**Subject: Transmittal of Class 1 Permit Modification Request to Remove Structure TA-55-PF-190 from the Los Alamos National Laboratory (LANL) Hazardous Waste Facility Permit, EPA ID No. NM0890010515**

**Class 1 Permit Modification Request for Removal of  
the TA-55-PF-190 Mobile Structure from the  
Technical Area 55 Outdoor Pad**

### **Removal of One Structure (TA-55-PF-190) from Technical Area 55-4 Outdoor Container Storage Pad**

**Figure G.26-1: Technical Area 55 Outdoor Container Storage Unit Grid Sampling and Additional Sampling Locations**

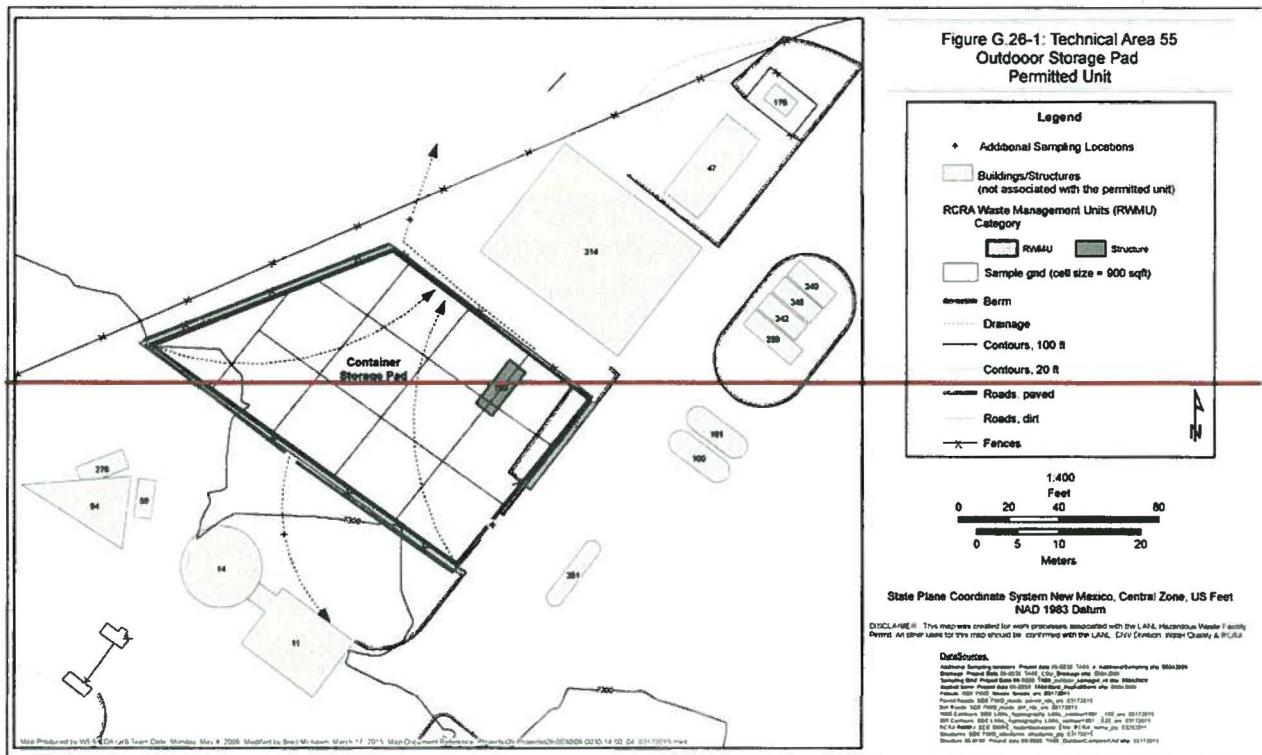
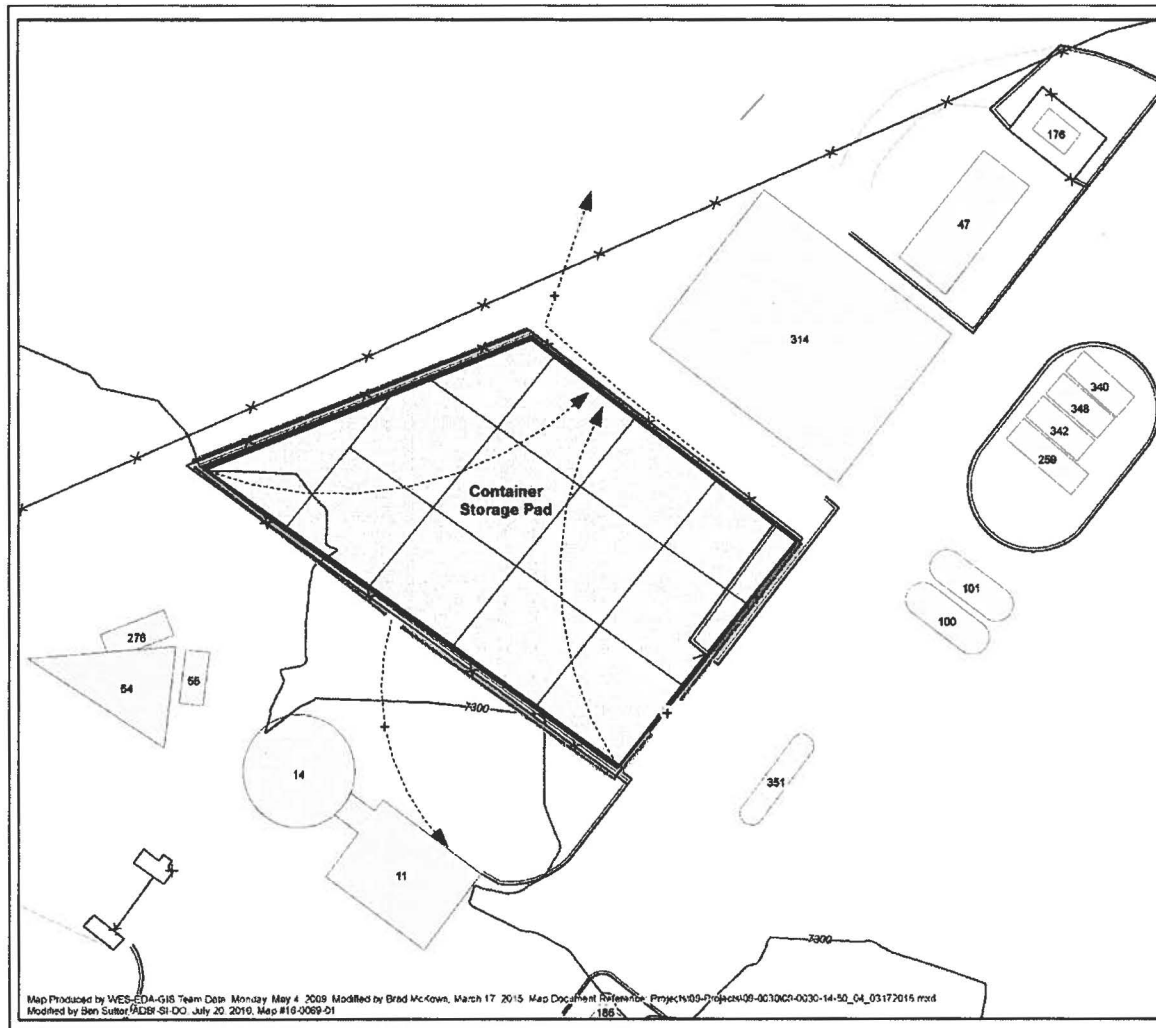
Attachment G.26, *Technical Area 55, Outdoor Storage Pad Closure Plan*, proposed revision reflects removal of the TA-55-PF-190 structure from the description of unit to be closed. Sections 2.0, 5.2.2, 5.3.2, 6.4 and 7.0 have been updated with the proposed changes. Figure G.26-1 *Technical Area 55, Outdoor Container Storage Unit Grid Sampling and Additional Sampling Locations* proposed revision reflects removal of the structure, however, the area sample locations remain unchanged as required sample locations for execution of the G.26 closure plan.

Figure 45  
Technical Area (TA)-55, Building 4, Outdoor Container Storage Pad

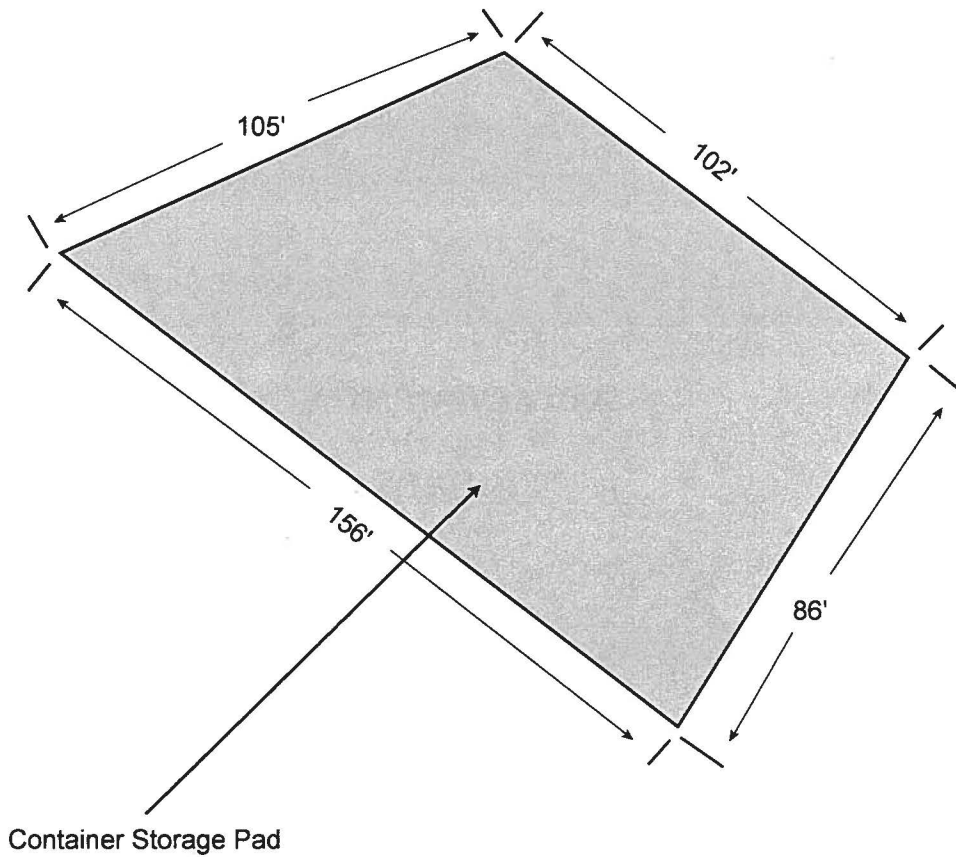
Attachment N, *Figures, Figure 45, Technical Area 55, Building 4, Outdoor Container Storage Pad*, revision reflects the proposed removal of the one structure (TA-55-PF-190) from the TA-55-4 Outdoor Container Storage Pad.
